NACELLE - EXHAUST – THRUST REVERSER - LOWER OUTBOARD TRACK BEAM – MODIFICATION OF

V2500-D5

V2500-NAC-78-0175

# V2500 Propulsion System - Nacelle SERVICE BULLETIN

Lower Outboard Track Beam Fittings Installation Figure 1 (sheet 1)

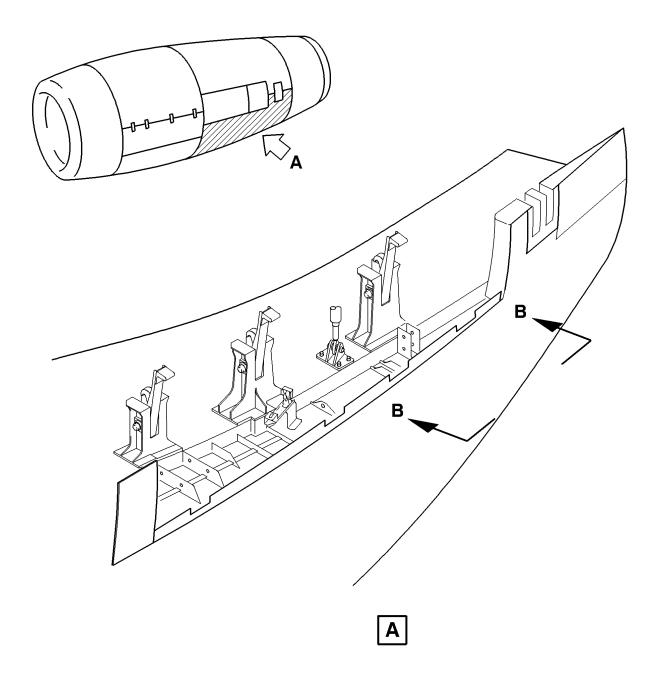
- (1) Remove material from the notches on the lower outboard track assembly as shown in Figure 1.
- If necessary, remove material from the heatshield to make space for the 290K0002 fittings. (2)
  - Remove material from the heatshield to make space for the 290K0002 fittings. (a)
  - SOLVENT (COMAT 01-438) IS CLASSIFIED AS A HAZARDOUS WARNING: MATERIAL WHICH MAY CAUSE INJURY OR ILLNESS IF NOT PROPERLY USED. THIS PRODUCT SHOULD BE USED ONLY IN ACCORDANCE WITH THE MANUFACTURER'S SPECIFIC SAFETY AND HEALTH RECOMMENDATIONS. PRIOR TO USE OF THIS PRODUCT, CAREFULLY READ THE APPLICABLE "MATERIAL SAFETY DATA SHEET" AND FOLLOW ALL LISTED SAFETY AND

- (8) Put the 290K0002-3 (-4) and 290K0002-5 (-6) fittings into position on the lower track beam. Make sure the fittings are even (flush with the outer surface and edge of the track beam and centered as much as possible in the notches. Use liquid shim (CoMat 08-021) (0.030 inch (0,76 mm) maximum thickness) and the S700S0497-199 shims to fill the spaces between the fittings and the track beam. Use release agent (CoMat 02-158) to keep the liquid shim from sticking to the S700S0497-199 shims and the 290K0002 fittings. Refer to Figure 1.
- (9) Drill the holes for the HL41V-6-4 and HL40V-6-5 pins through the track beam, the 290K0002 fittings, and shims (if any).
- (10) Install the 290K0002 fittings on the track beam with the HL41V-6-4 pins, HL40V-6-5 pins, and HL97V-6 collars. Wet install the fasteners with primer mix.

Lower Outboard Track Beam Fittings Installation Figure 1(sheet 2)

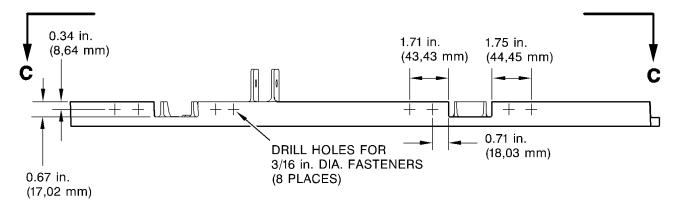
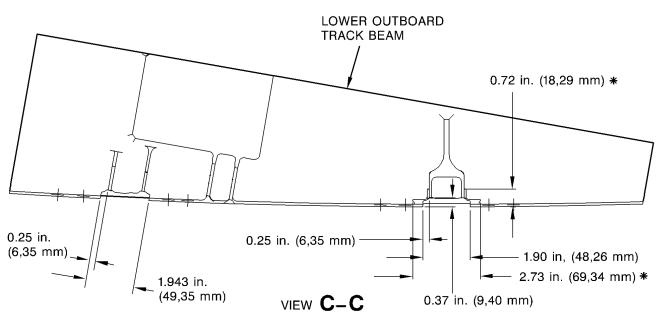
VIEW **B-B**FASTENER HOLE PATTERN
AND MATERIAL REMOVAL DIMENSIONS

\* REMOVE MINIMUM FILLET MATERIAL AS REQUIRED SO THAT 290K0002 FITTING WILL FIT FLUSH AGAINST TRACK BEAM SURFACE.
